**WESTON RESERVOIR DAM  
MA 00798**

**PHASE I INSPECTION REPORT  
NATIONAL DAM INSPECTION PROGRAM**

NATIONAL PROGRAM OF INSPECTION OF NON-FEDERAL DAMS  
DRAFT REPORT REVIEW COMMENTS

Weston Reservoir DAM, IDENTITY NO. MA 00798

PLAN VIEW OF DAM

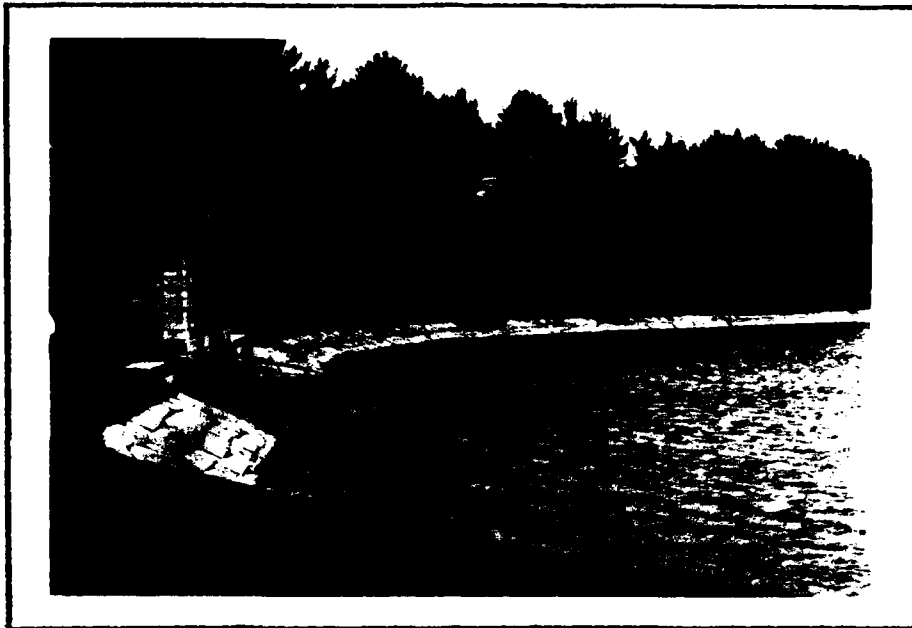
*3) Show area of seepage on  
photo plan.*
